GOLD PARK HOMES

PROJECT/LOCATION
MCLAUGHLIN AND MAYFIELD
BRAMPTON, ON

SITE PLAN

BUILDING STATISTICS			
REG. PLAN No.	43M-2005		
ZONE	R1F-9.0-41FT		
LOT NUMBER	61		
LOT AREA(m) ²	335.34		
BLDG AREA(m) ²	N/A		
LOT COVERAGE(%)	N/A		
No. OF STOREYS	2		
MEAN HEIGHT(m)	8.71		
INT. GARAGE DIMS(m)	5.59 X 6.10		
GARAGE DOOR WIDTH(m)	2 X 2.44		
i .

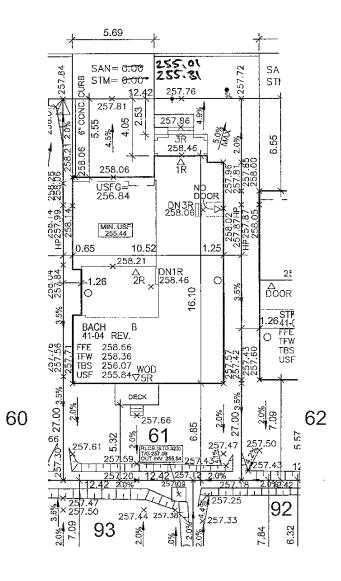
- No final utility location information at this time. Urbantech will not be responsible for future changes to design. Builder should notify purchaser's that street hardware and above ground utility furniture may be added or removed from their frontages.
- 2) Builder to lower underside of footings where adjacent to RLCB leads.
- B) Builder to stake out driveway curb depressions at time of curb installation.
- 4) Builder to verify location of all hydrants, street lights, transformers and all other services. If min. dimensions are not maintained as per City standards, builder is to relocate at his own expense.
- Builder to confirm service connection elevations and review for absence of conflict prior to footing excavation.
- 6) Final fence design have not been provided at this time. Purchaser to be advised that actual fencing details may not be as shown on this plan.

NOTE: BUILDER TO VERIFY LOCATION OF ALL HYDRANTS, STREET LIGHTS, TRANSFORMERS AND OTHER SERVICES. IF MIN. DIMENSIONS ARE NOT MAINTAINED BUILDER IS TO RELOCATE AT HIS OWN EXPENSE.
